Comal County Environmental Health

OSSF Inspection Sheet

Permit of Authorization to Construct an On-Site Sewage Facility Permit Valid For One Year From Date Issued

Permit Number: 116922
Issued This Date: 02/07/2024
This permit is hereby given to: Gonzalo Ochoa

scale 1" = 30'

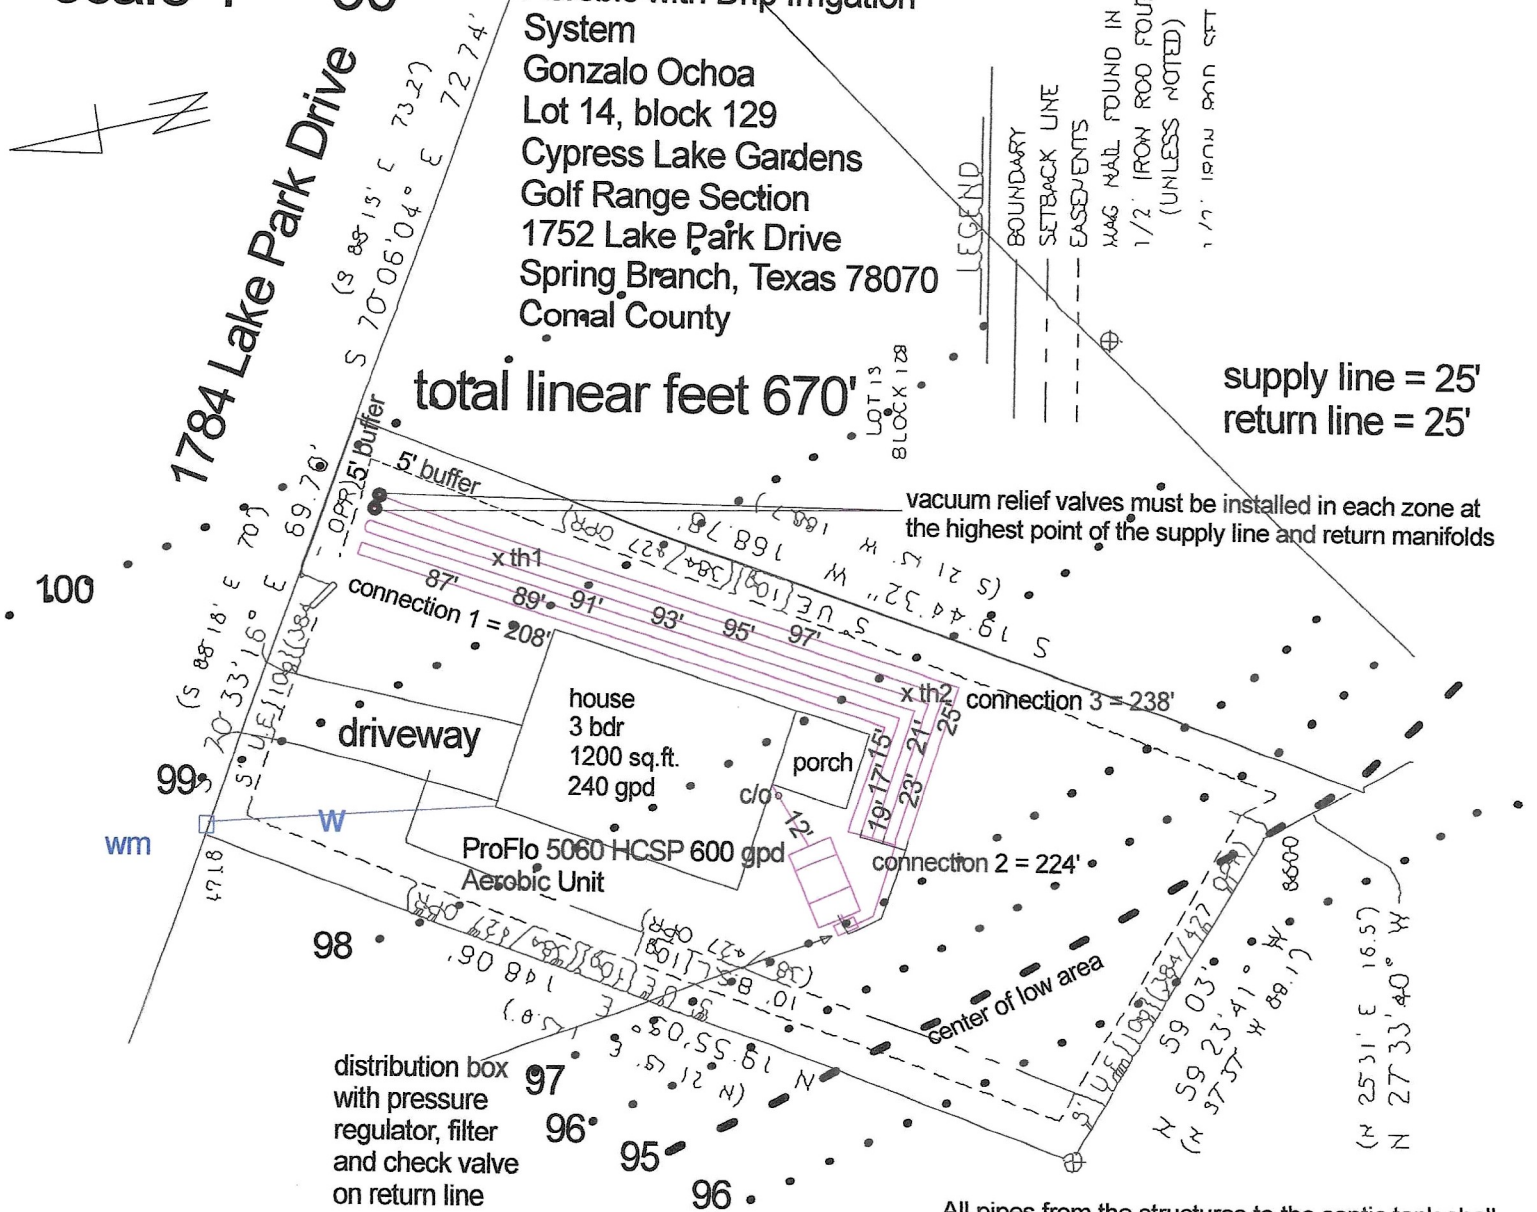
1/29/25 CA: Water meter less than 10 ft from field. Expose waterline to verify location and sleeving. Will need re inspection fee. System covered
